PERCOLATION TESTING

HOWARD COUNTY HEALTH DEPARTMENT

SUBDIVISION Beaufort Park LOT NO. 11 reperc
ROAD AND DESCRIPTION 12401 Kondrup Drive

RE: Percolation Test Results
Application Number: A17718
Proposed Use: Adjustment to Recorded
Sewage Easement
Property ID: Beaufort Park Estates
Lots 10, 11 and 12
Kondrup Drive

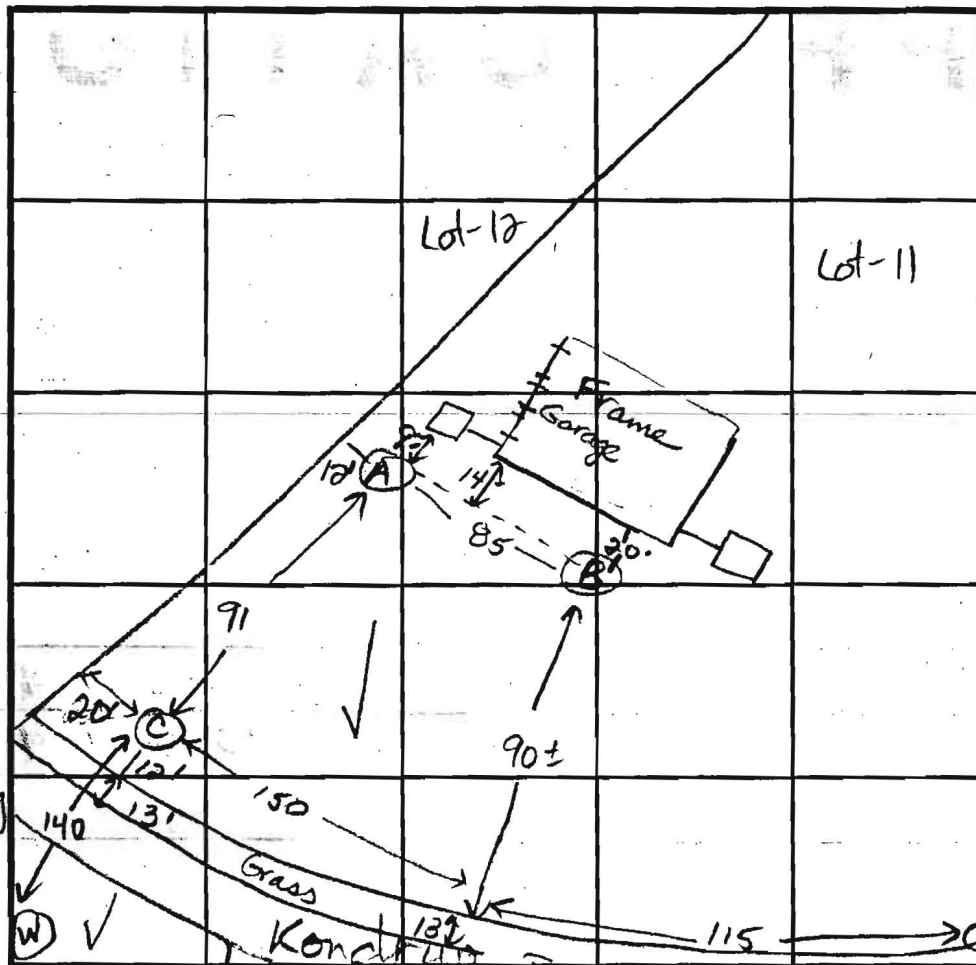
REASONS FOR REJECTION OR HOLDING 11-9-92 Pending perc hole location and plan review. JON Wadeau

REMARKS: Soils uniform with exception of hole B with 1.5 ft of new fill. Maintain 20 ft to existing house.
 TESTED BY: J.E. Nadreau ALSO PRESENT: Fyock, Daffer
 TRENCH DESIGN DATA: AVERAGE PERCOLATION TIME: 5 min TRENCH WIDTH: 2.0 ft
 INLET DEPTH: 3.0 MAXIMUM BOTTOM DEPTH: 7.0 SQ. FT./BEDROOM: 210

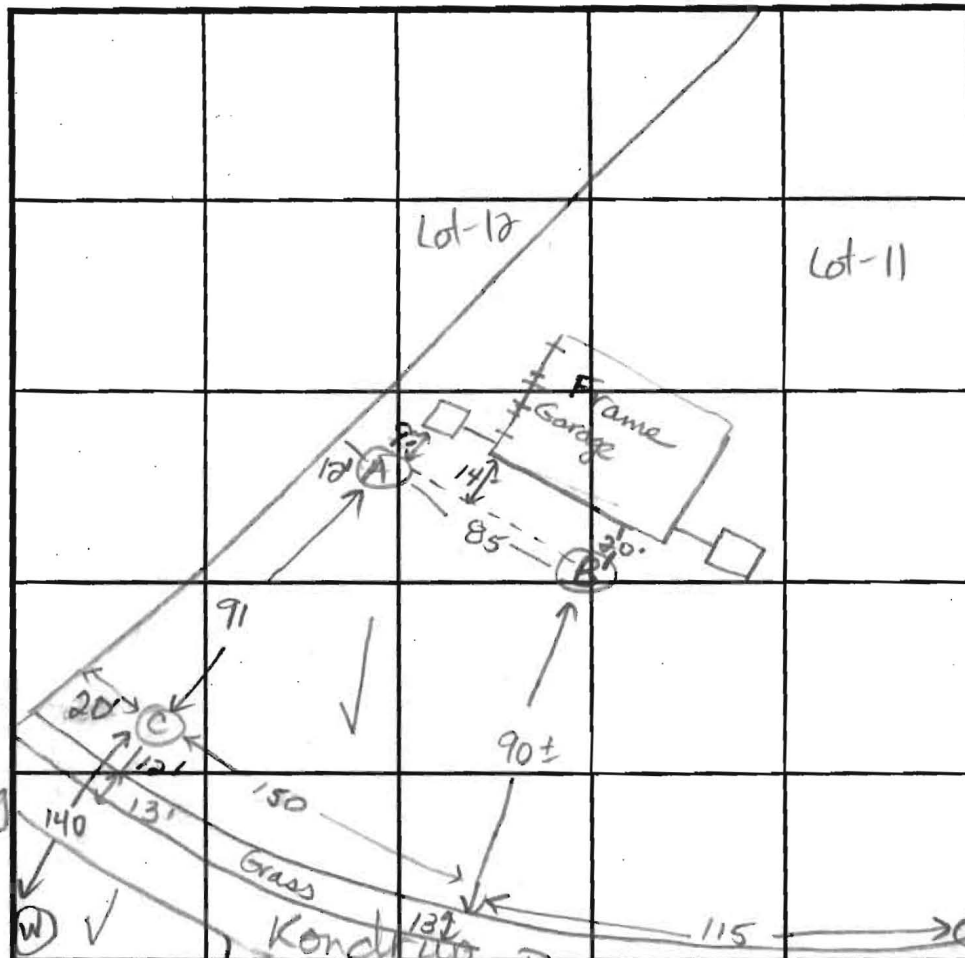
REASONS FOR REJECTION OR HOLDING 11-9-92 Pending perc hole location and plan review. J. Wadeau

REMARKS: Soils uniform with exception of hole B with 1.5ft of new fill. Maintain 20 ft to existing house.
 TYPE OF SOIL: of new fill. Maintain 20 ft to existing house.
 TESTED BY: J.E. Nadeau ALSO PRESENT: Fyock, Daffer
 TRENCH DESIGN DATA: AVERAGE PERCOLATION TIME: 5 min TRENCH WIDTH: 2.0 ft
 INLET DEPTH: 3.0 MAXIMUM BOTTOM DEPTH: 7.0 SQ. FT./BEDROOM: 210
